SUBJECT: Closure of Twenty Second St between Andy Holt Ave Tax Map 108CJ013
MPC File # 12-B-14-SC; City Blocks 10580 and 10582

**Re: Right-of-Way Closure Request 12-B-14-SC
Block No. 10580\10582
CLT No. 108
Parcel No. 25**

File No. 12-B-14-SC Closure of Twenty Second Street Sewer
BETWEEN Andy Holt Ave and Northern Terminus CLT MAP#102 PARCEL #25 CITY BLOCK #10580110582

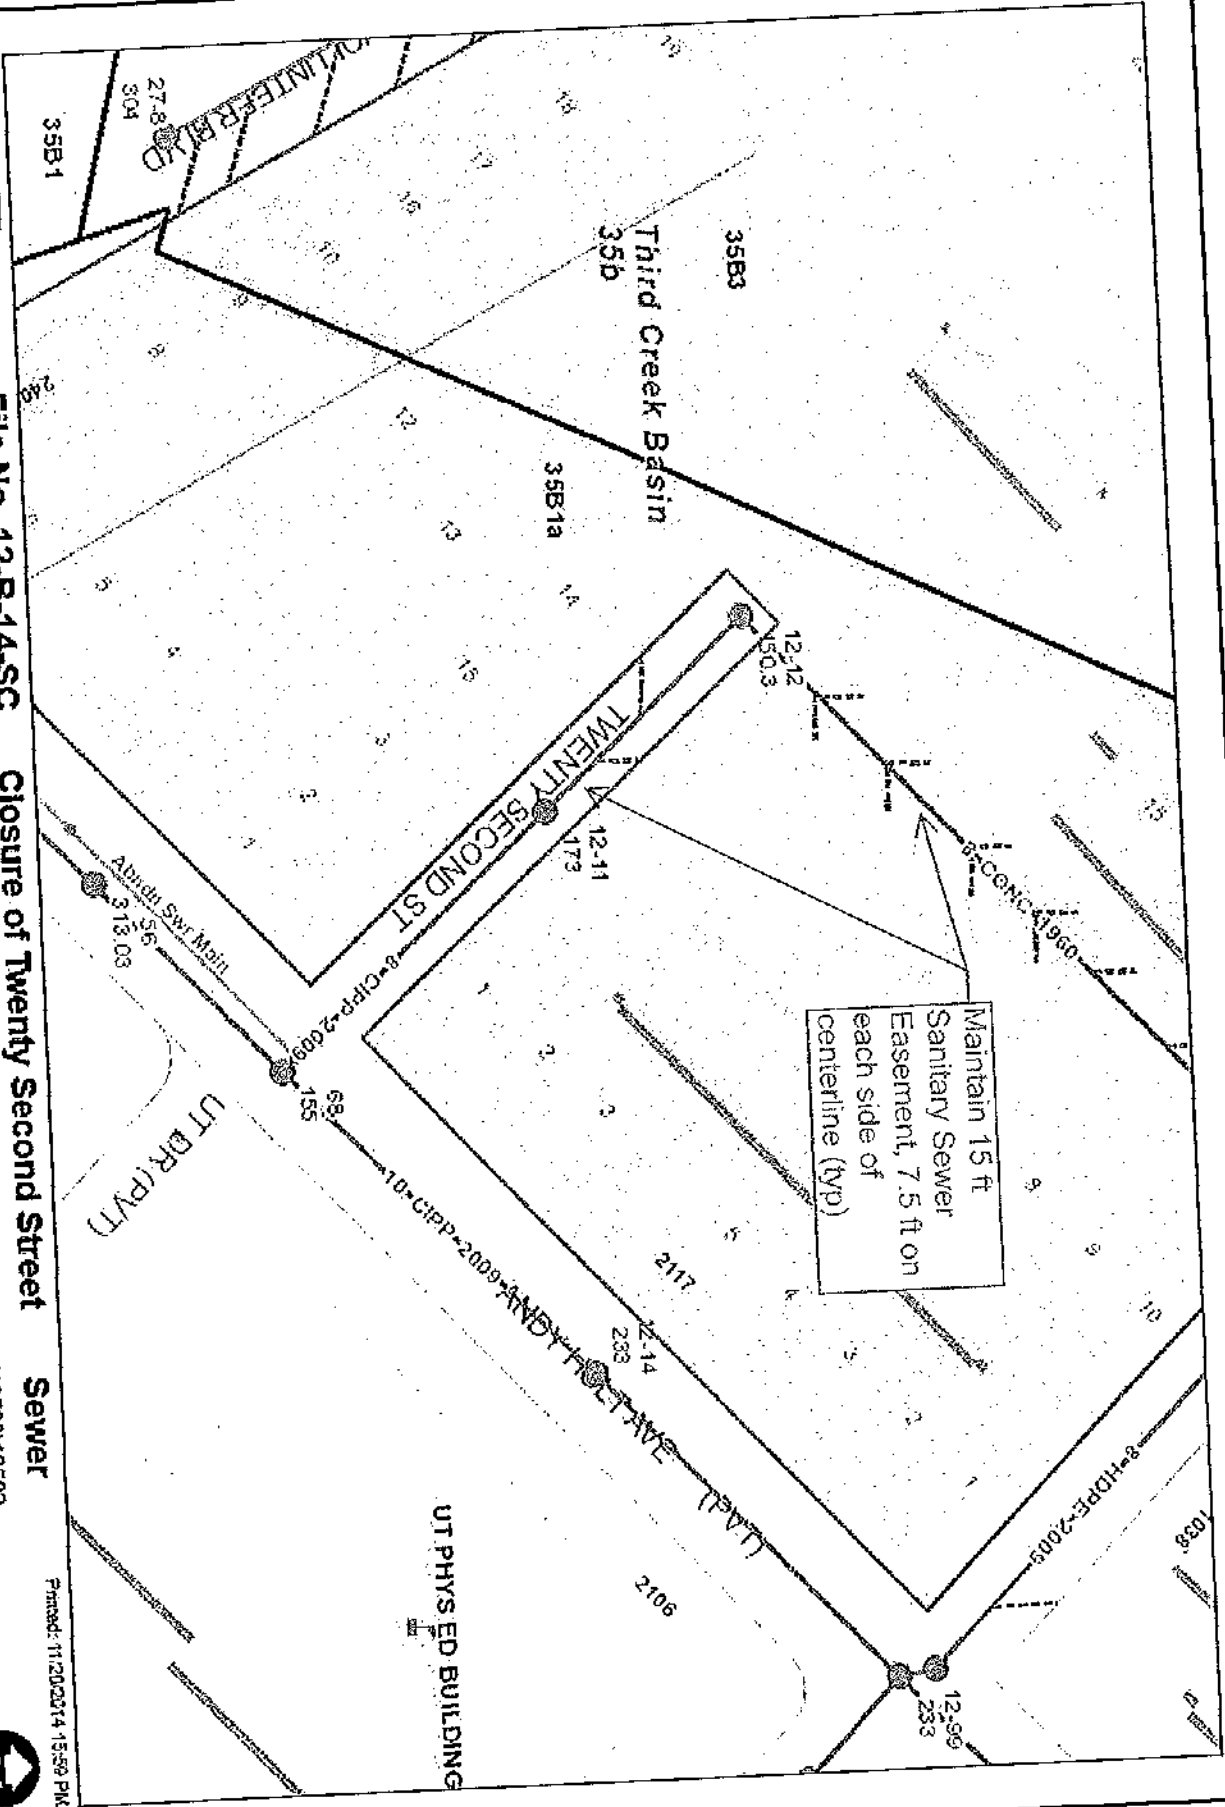
Should this right-of-way be closed, KUB will require the following permanent easement for its utility facility.

Sewer – 7.5 feet on each side of the centerline of the wastewater line, 15 feet total width

Maintain 15 ft Sanitary Sewer Easement, 7.5 ft on each side of centerline (typ)
